CITY COUNCIL AGENDA ITEM

CITY OF SHORELINE, WASHINGTON

AGENDA TITLE: DEPARTMENT:	Transportation Master Plan Update Public Works			
PRESENTED BY:	Kirk McKinley, Transportation Services Manager			
ACTION:	Alicia McIntire, Senior Transportation Planner Ordinance Resolution Motion _X Discussion Public Hearing

ATTACHMENT A – RECOMMENDED CHANGES TO THE TRANSPORTATION MASTER PLAN

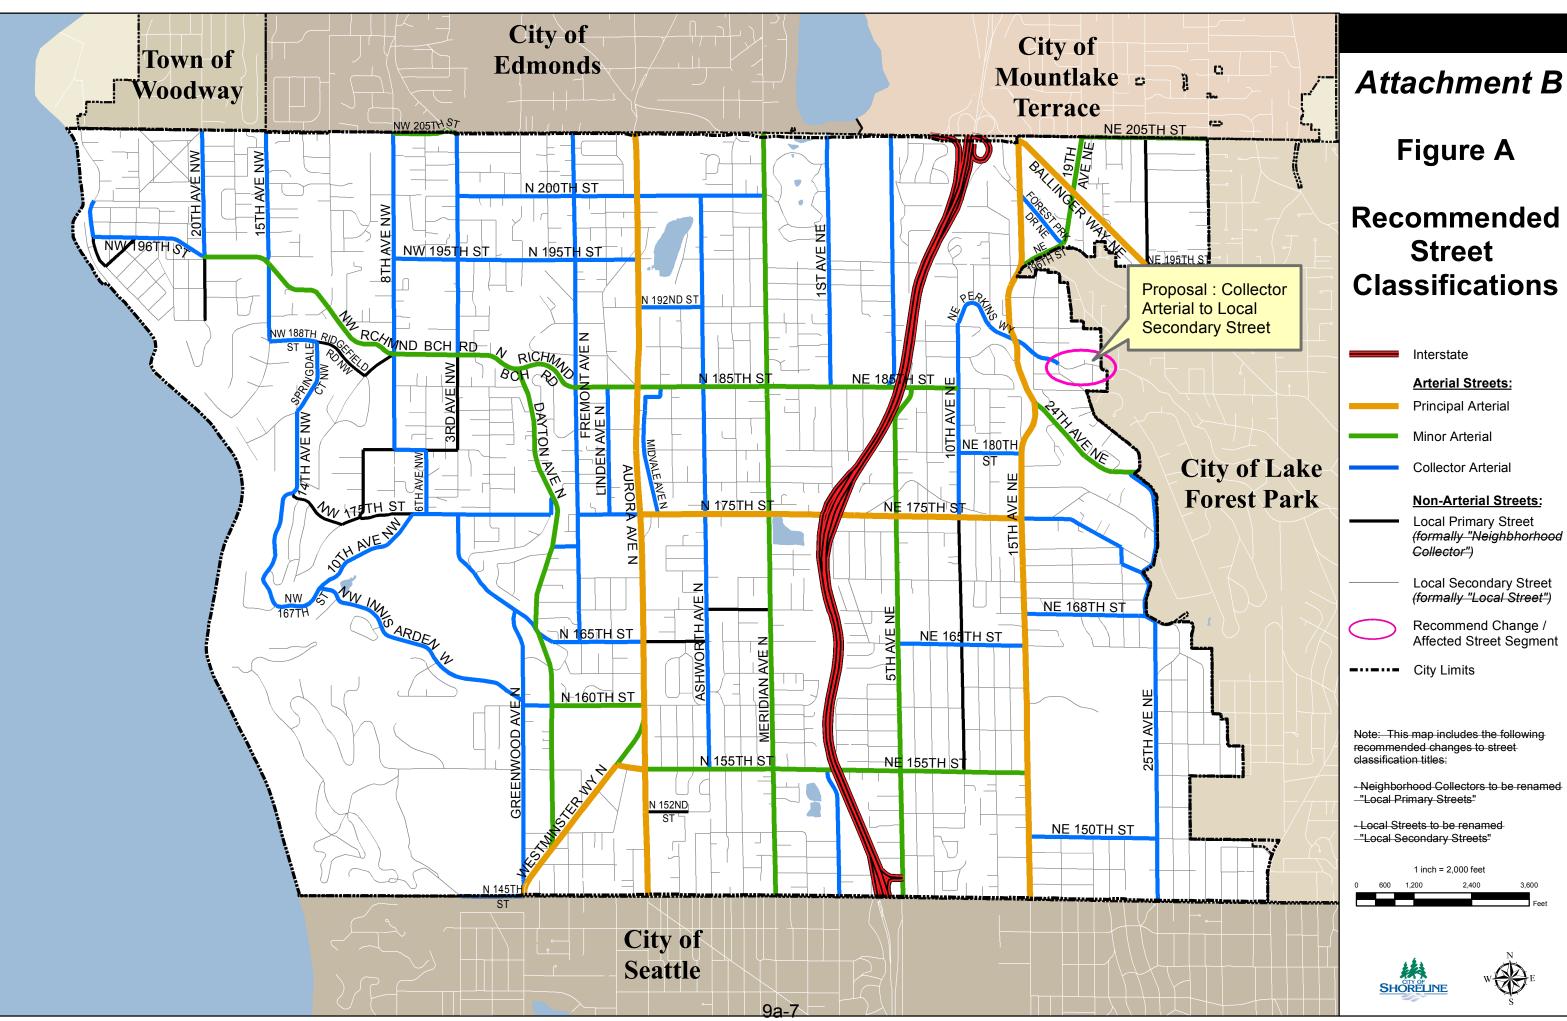
PAGE	SUBJECT	AMENDMENT	NOTES/EXPLANATION
1	Page 29 (Figure A)	Street Classification	 Change the street classification of NE Perkins Way from 18th Avenue to NE 22nd Avenue NE from Collector Arterial to Local Secondary Street Eliminate language identifying the previous title of Local Primary Street and Local Secondary Street 	 The Washington State Department of Transportation did not grant approval to classify this roadway segment as a Collector Arterial as desired by the City. This change renders the City's Street Classification Map consistent with their determination. The language identifying the previous title of Local Primary Street and Secondary Street is a remnant from the original draft public review plan. This language should have been removed when the plan was originally adopted in December 2011.
2	Appendix D	Master Street Plan	See below	 Correcting the right-of-way width for 5th Avenue NE from NE 185th Street to NE 195th Street, as the existing MSP identifies an incorrect requirement. Correcting the notes associated with the roadway segment on 10th Avenue NE from NE 175th Street to NE 185th Street. During the planning for the City's North Fork Thornton Creek Low Impact Development (LID) Stormwater Retrofit Project, staff found that space could be utilized behind the sidewalks on both the east and west sides of the roadway and is recommending removal of the language that specifies this allowance for the west side only. Include the width requirements for sidewalks associated with adjacent land uses on Local Secondary Streets. This requirement is already stated within the text of the TMP. Change the cross-section of the segment of Westminster Way N from Greenwood Avenue N to N 155th Street. Due to the potential redevelopment of Aurora Square as part of the Community Redevelopment Plan, the City should maintain a wider cross-section until such time as the roadway needs can be studied. Correct the termini of NE Perkins Way as a Collector Arterial at 18th Avenue NE in accordance with WSDOT's determination
